GJS Plot F, Manchester

Non-material Amendment | 10.07.2024

Z1-SHP-A180-RP-XX-NMA02 | P01

Updated proposal - Z1-SHP-G100-PL-B2-B5D801 - P02

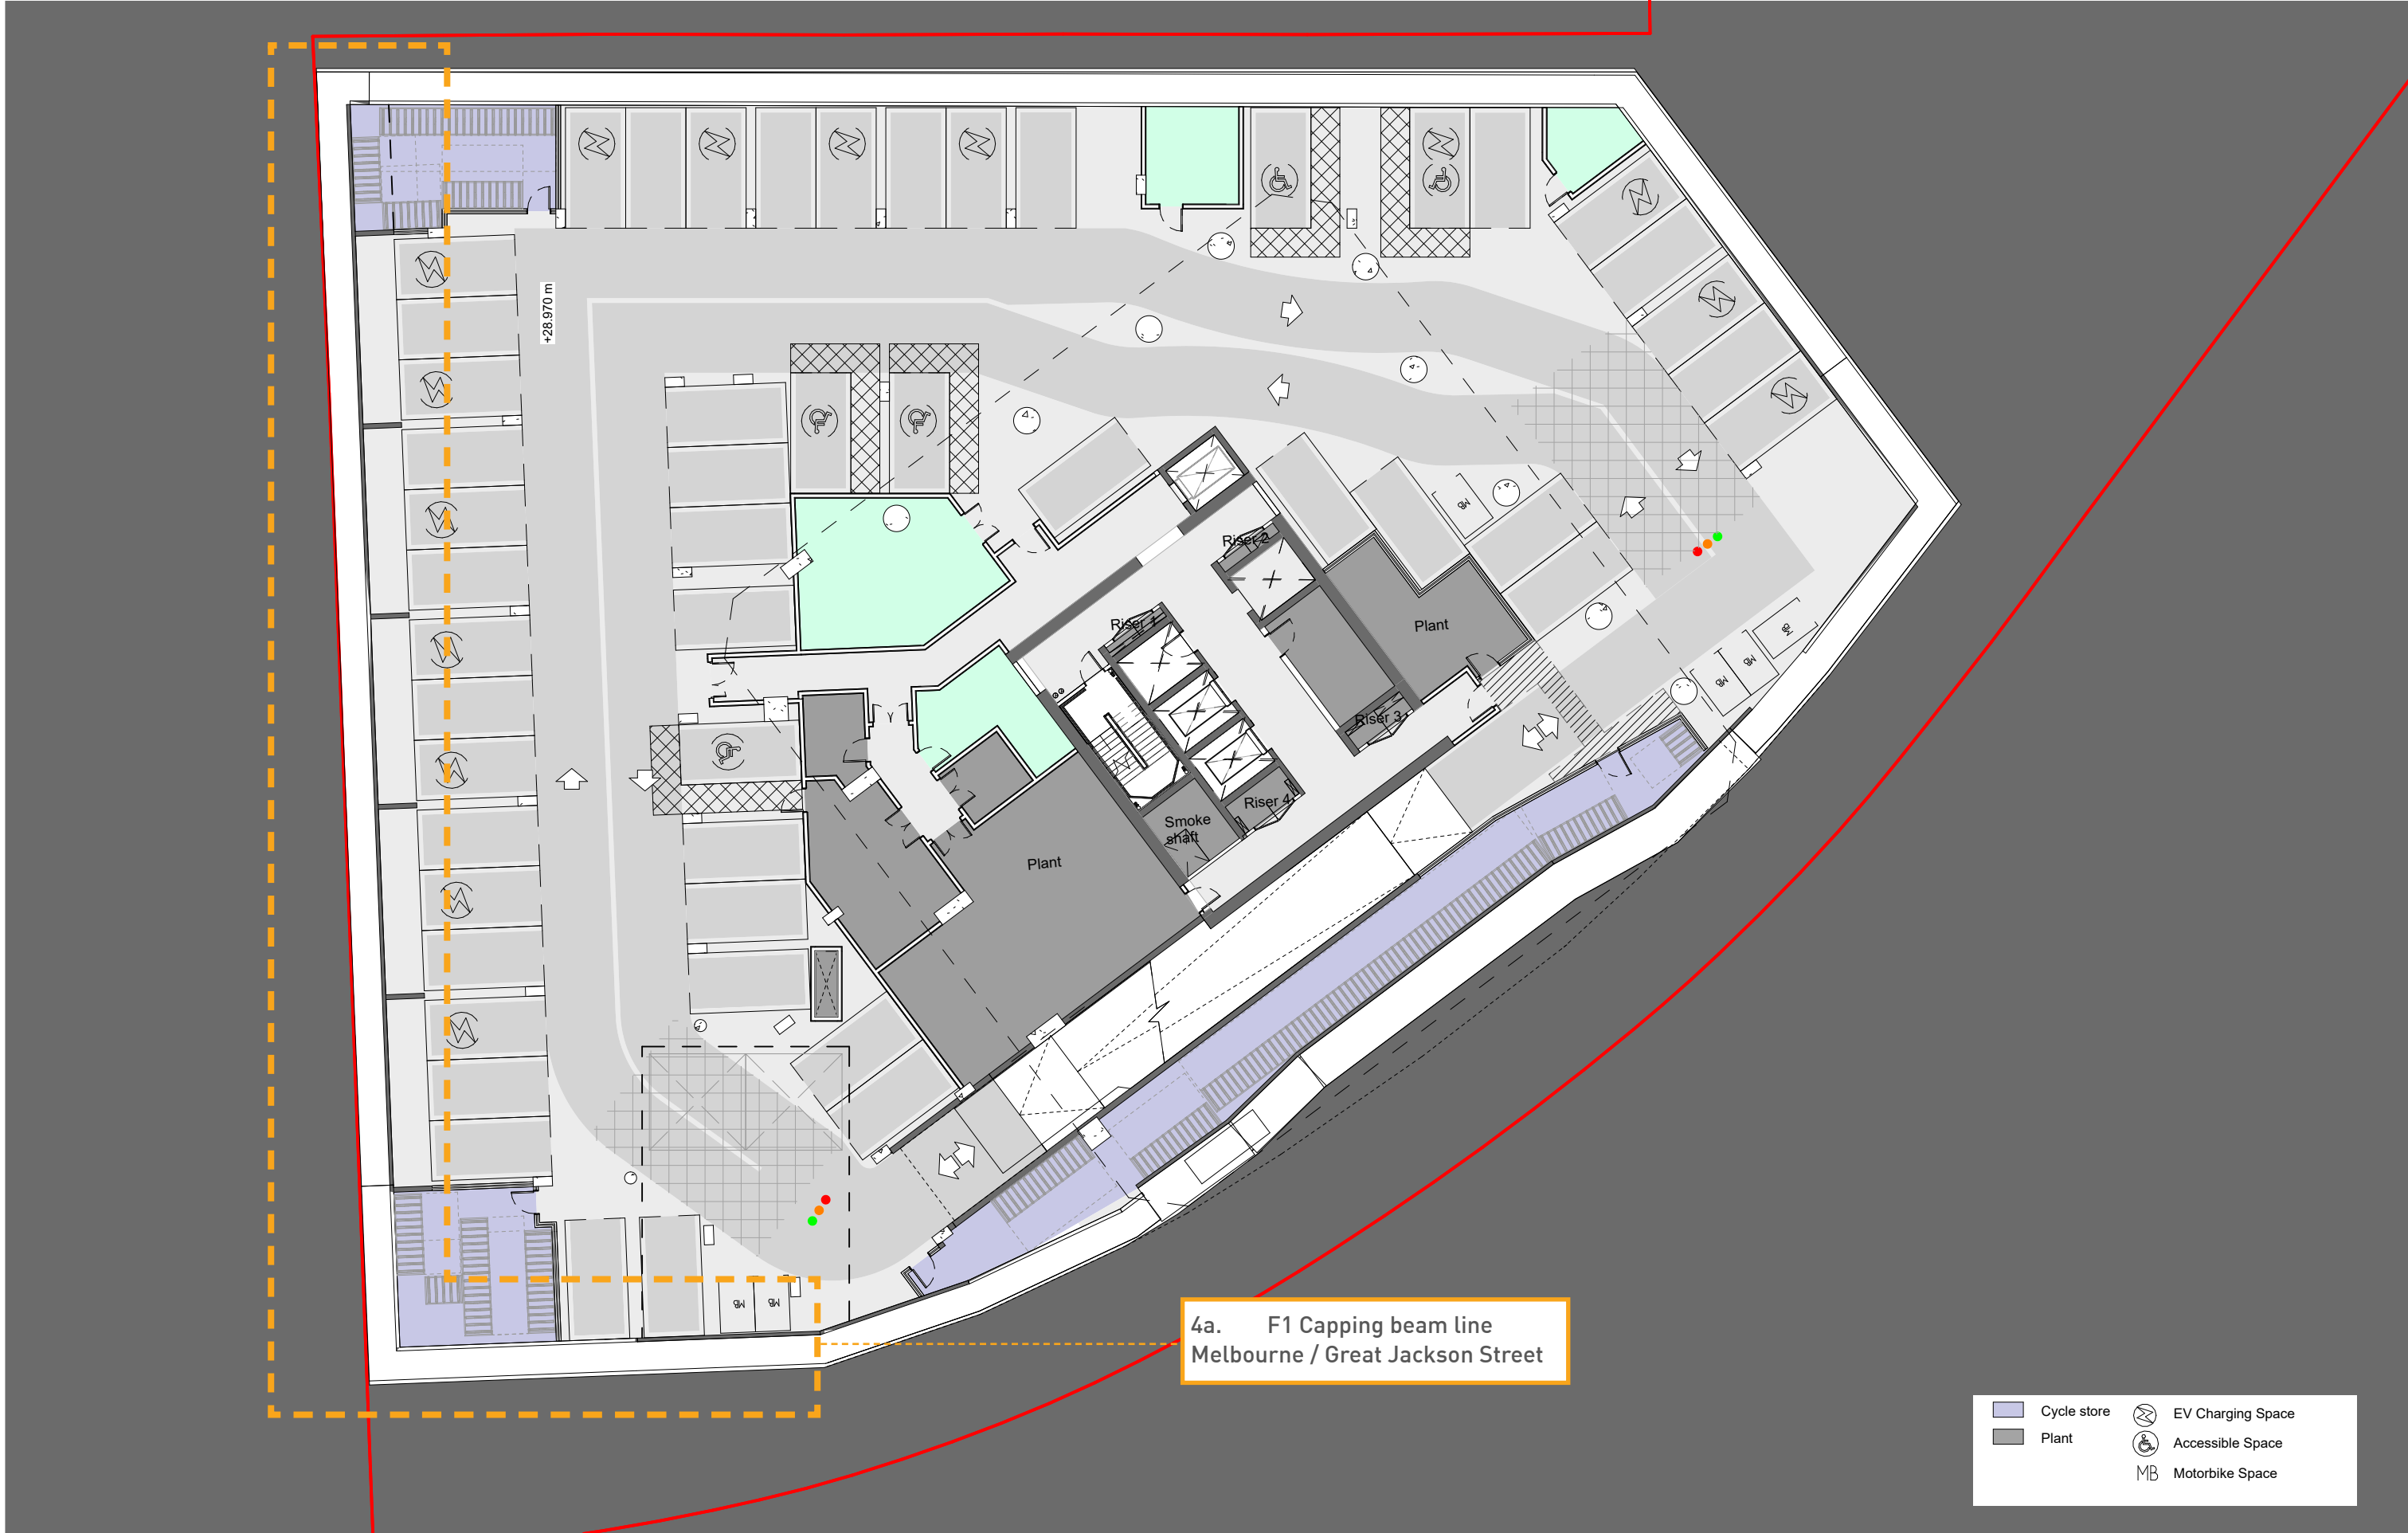
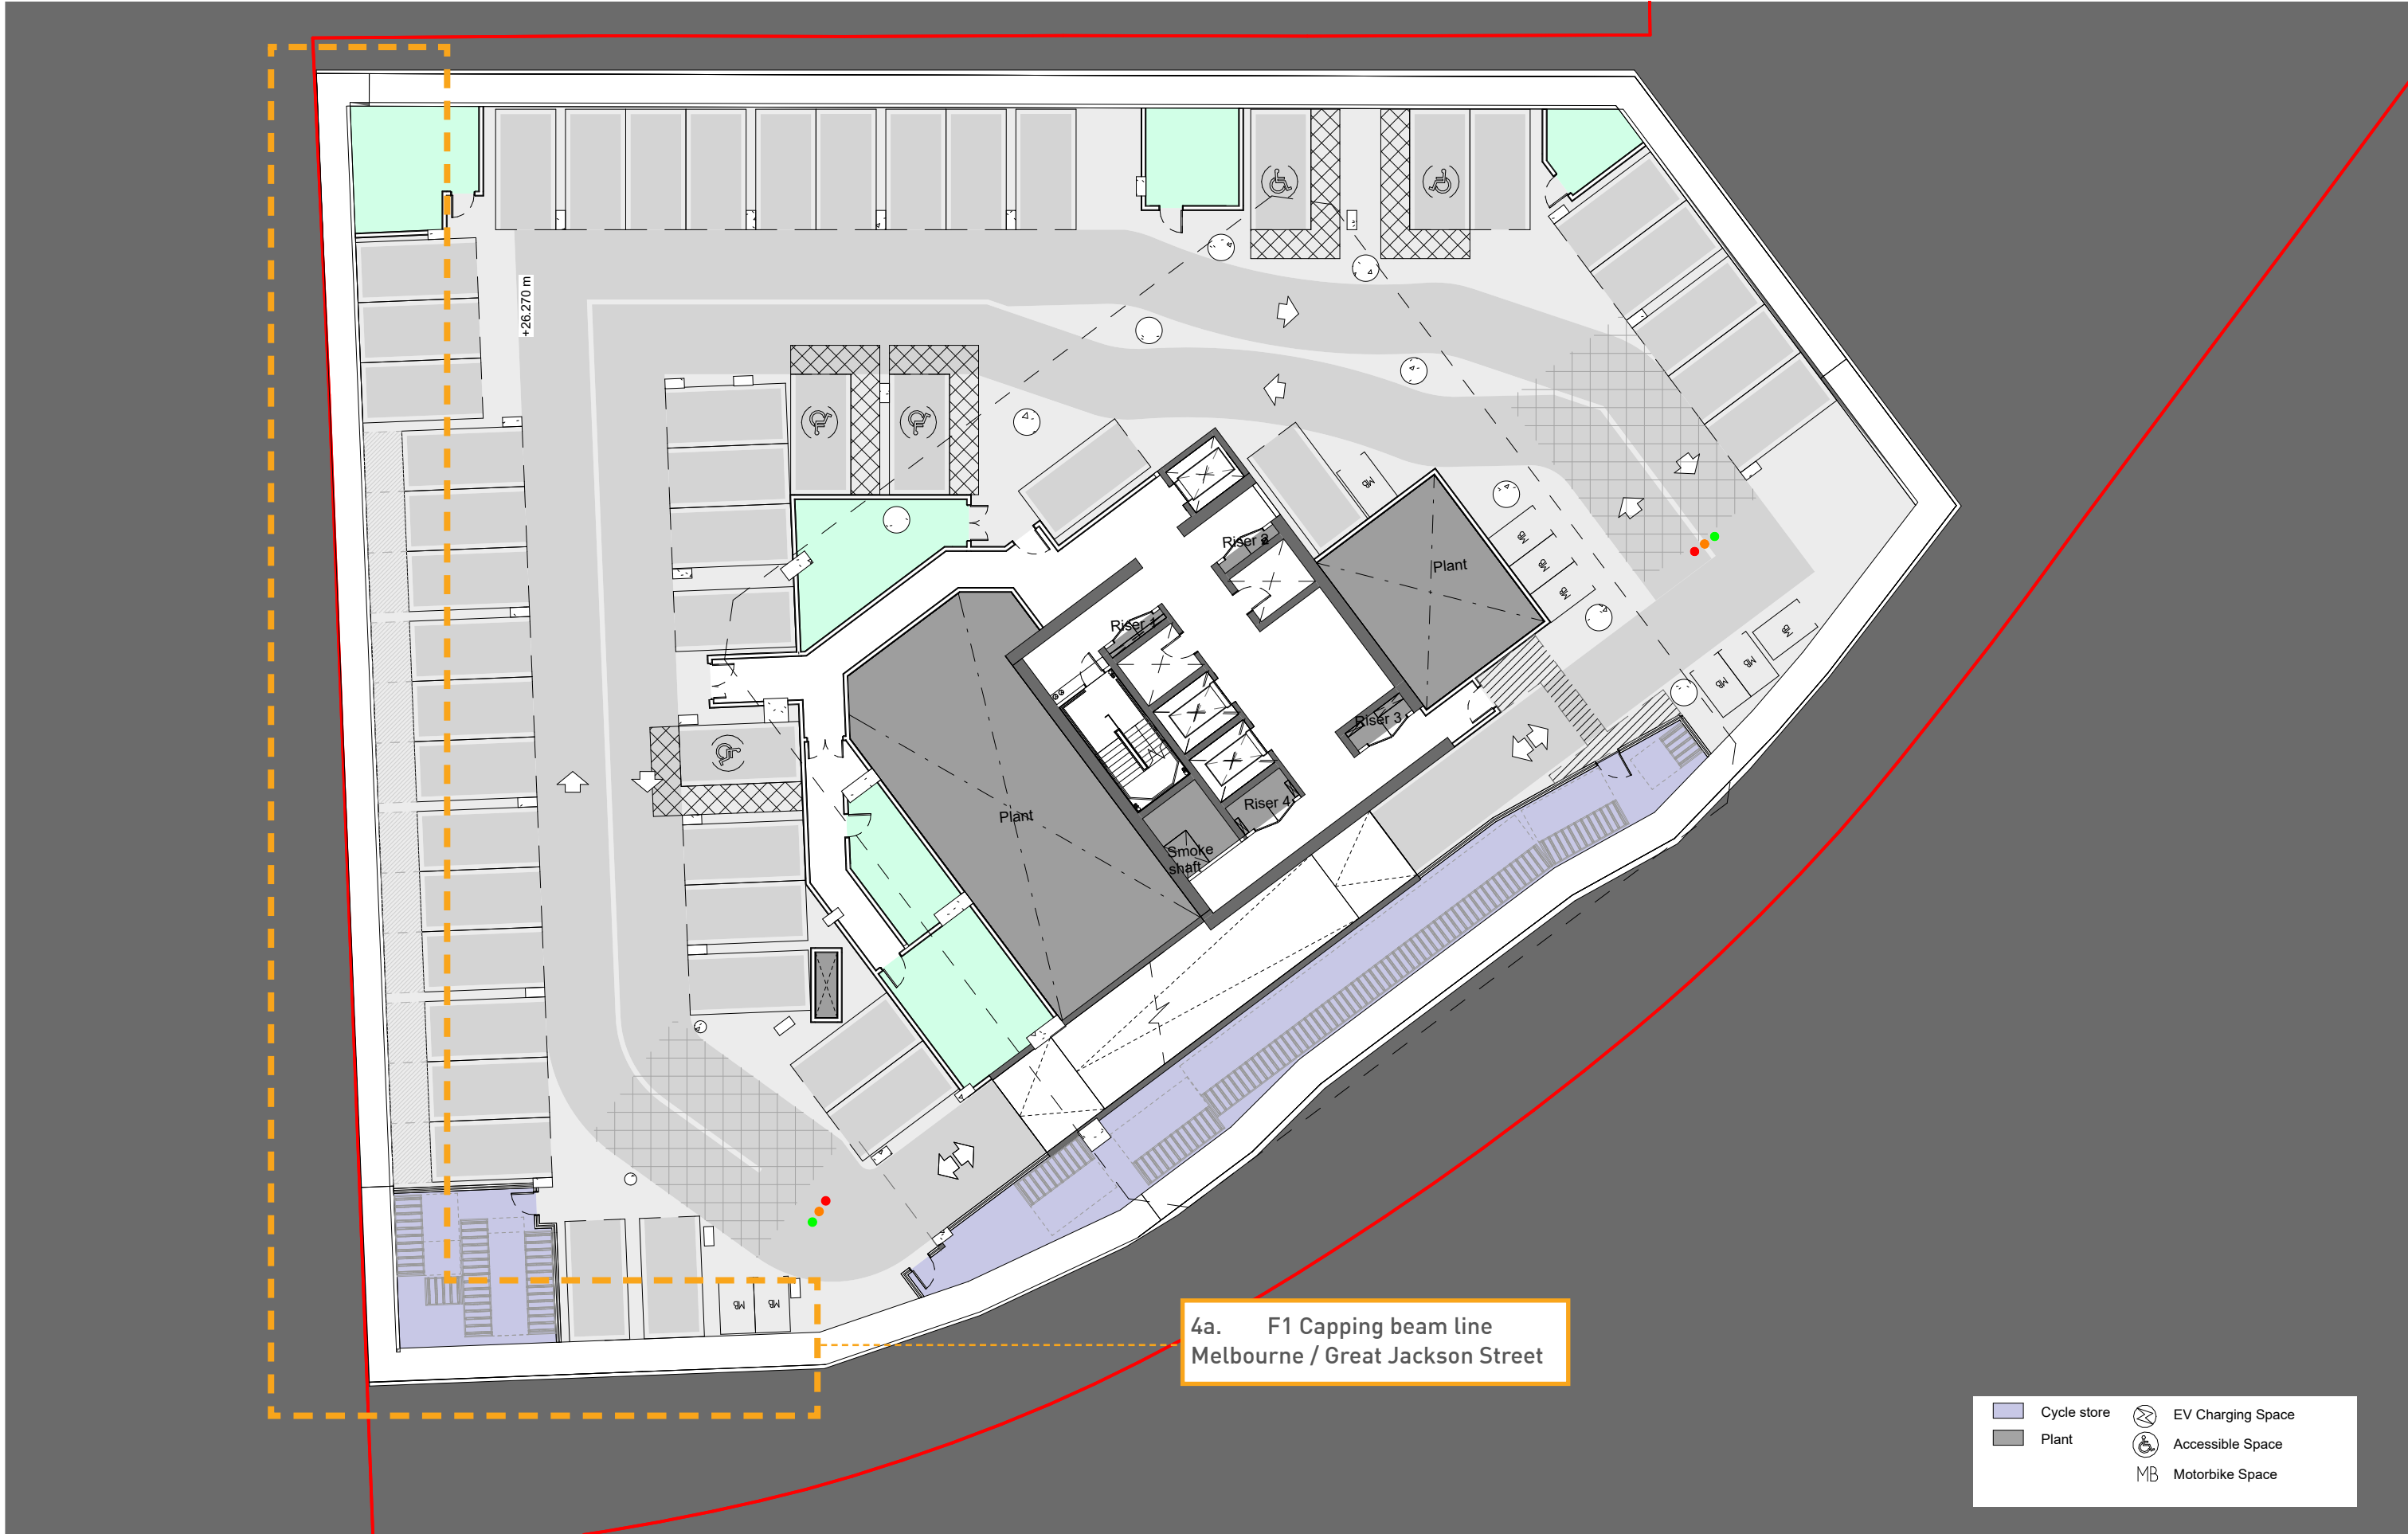
F1 Basement updates
 - a. **F1 Capping beam line Melbourne / Great Jackson Street**
The alignment of the capping beam for the F1 basement running down Melbourne Street has also been amended to tie in with the Crown Street Phase 3 application.

The revised arrangement reflects the applicant’s updated land ownership and allows for construction efficiencies within the back to back basement design.

Updated Proposal - F1-SHP-G200-PL-Grd-B5D801 - P03

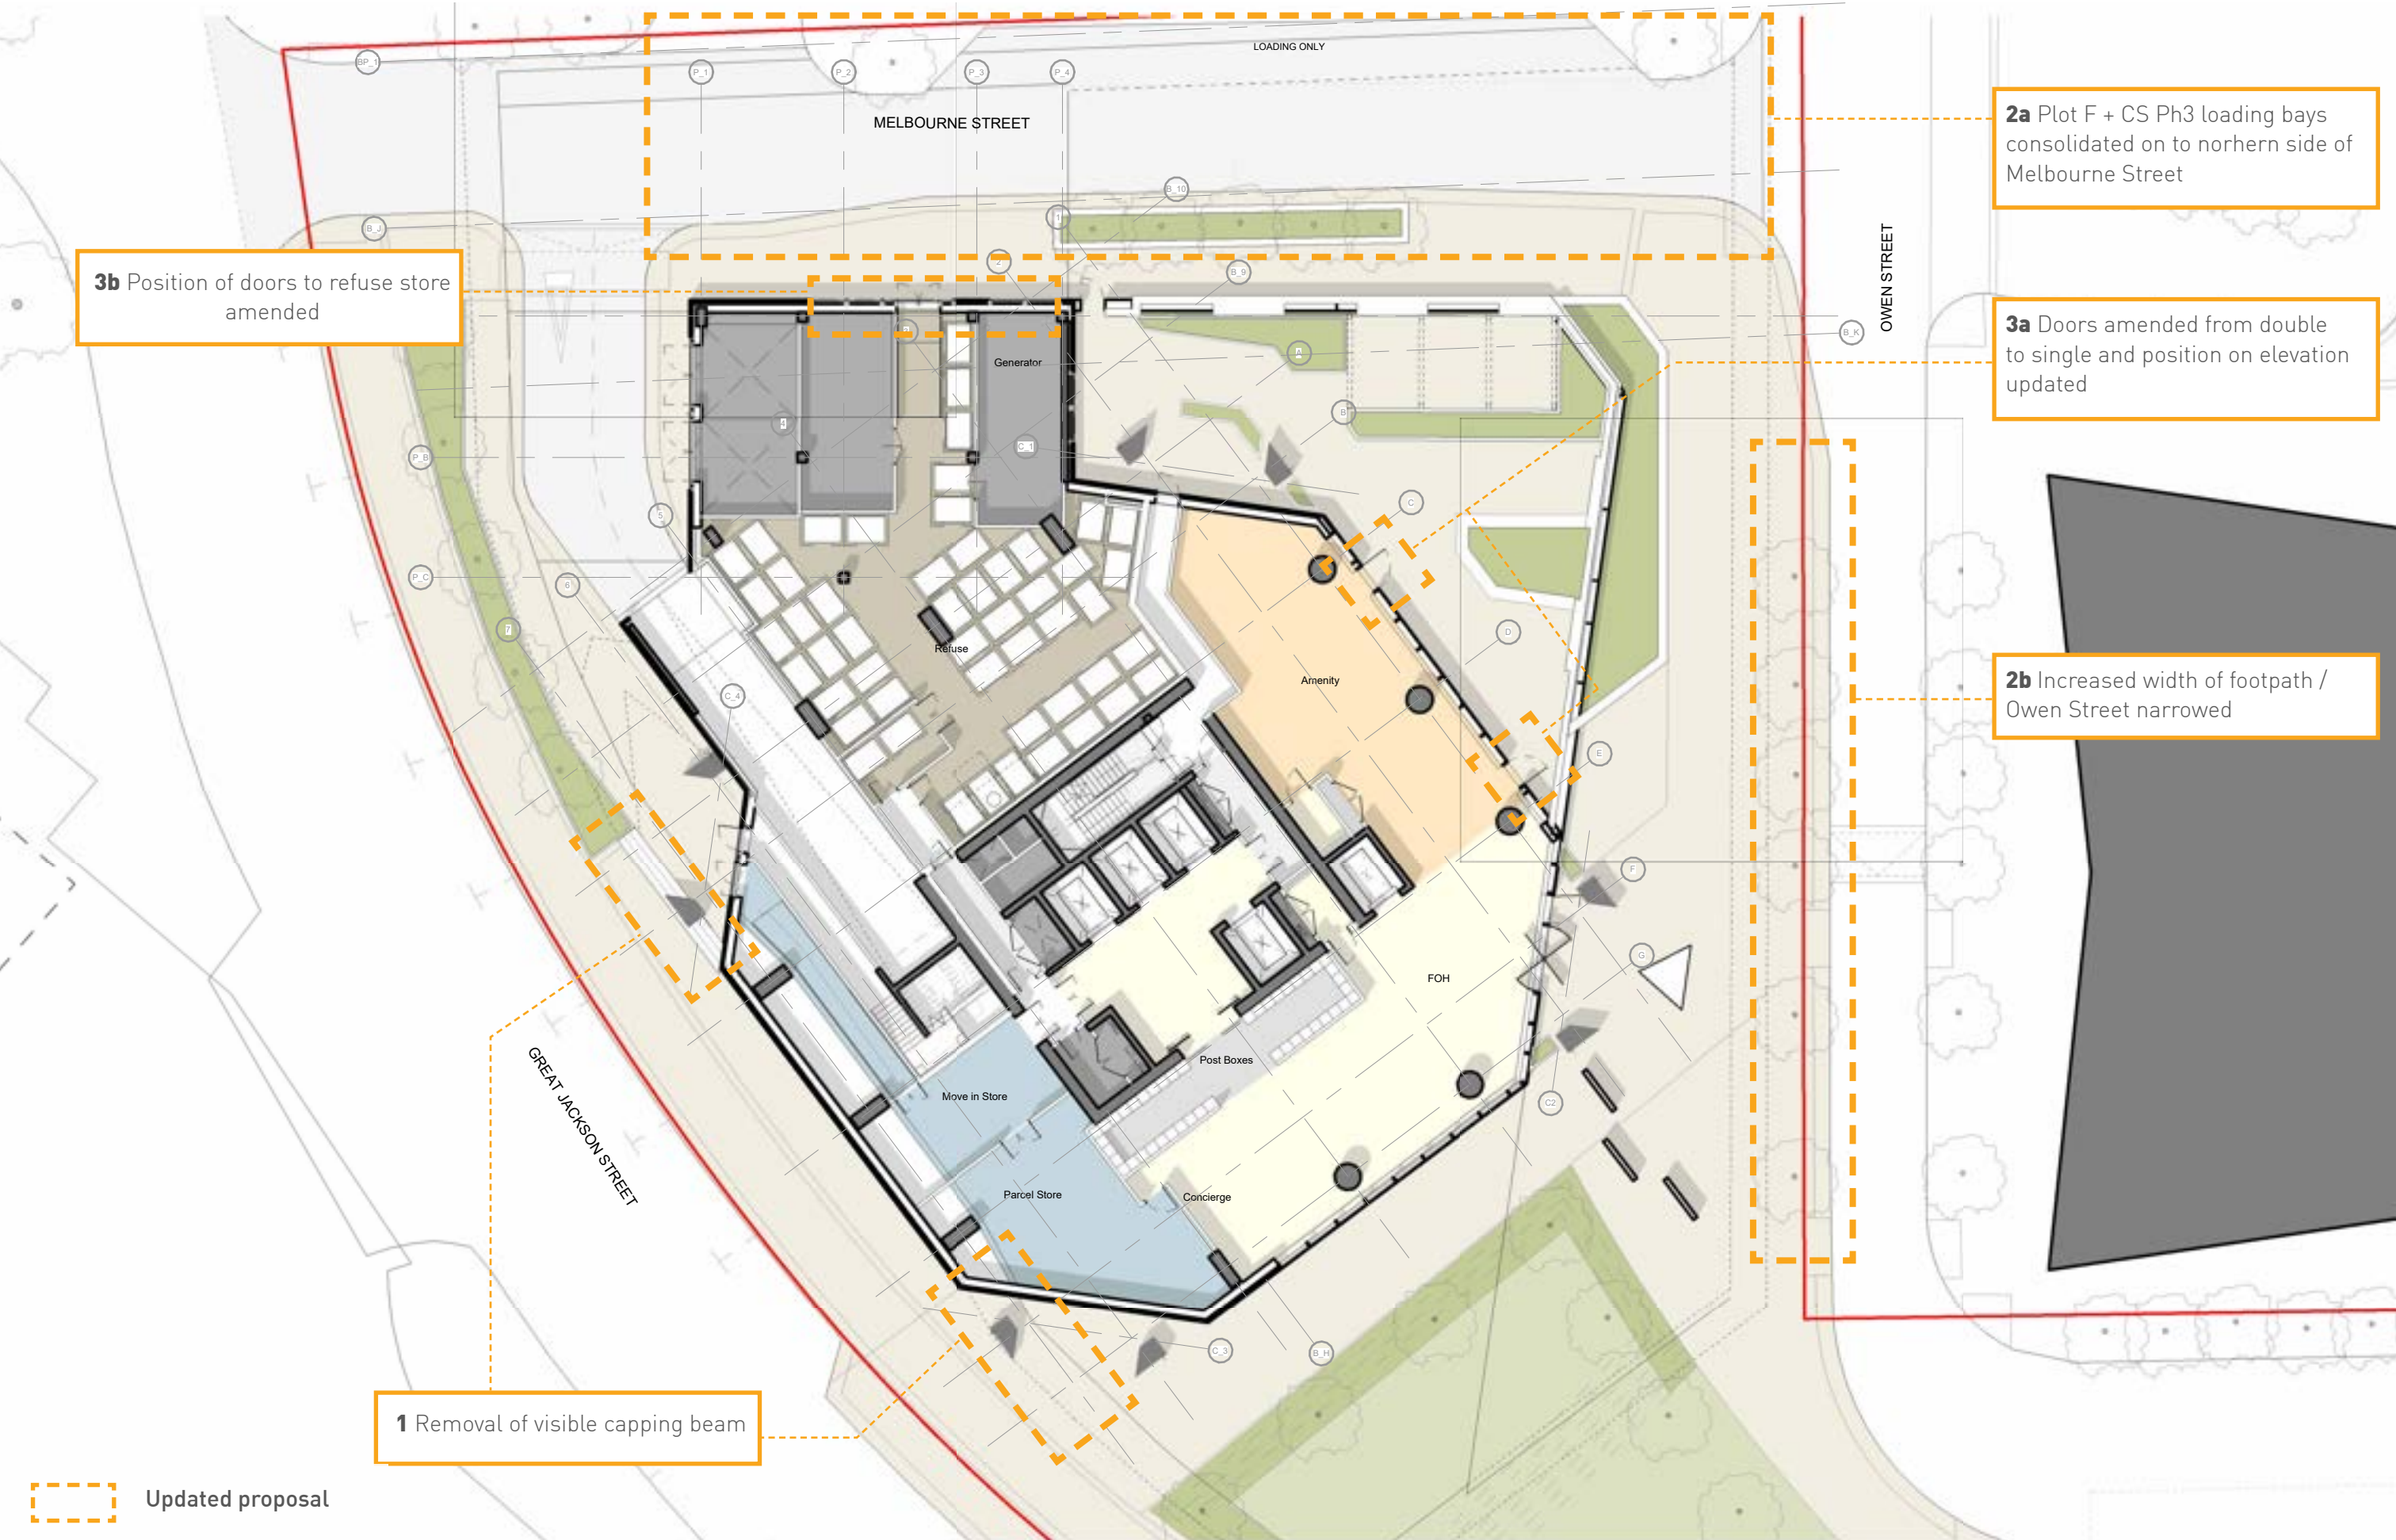
External doors positions amended / design updated
 - a. **F1 - Doors to residential amenity**
In order to provide a more successful interior layout, the two double doors on F1 have been amended to large single leafs and spaced further apart to provide a more usable internal space, whilst maintaining a symmetrical elevation.
 - b. **F1 - Doors to refuse store / car park smoke extract**
Due to the incorporation of the perforated screen in front of the car park extract louvres (as requested by MCC) on F1, it has been necessary to revise the free area requirement for basement the car park extract system and adjust the door position to the refuse store accordingly.
 - c. **F2 - Escape corridor doors**
The clear width of the escape doors has had to increase to provide the necessary width for escape. As such this would leave a narrow brick pier at the side of the door.
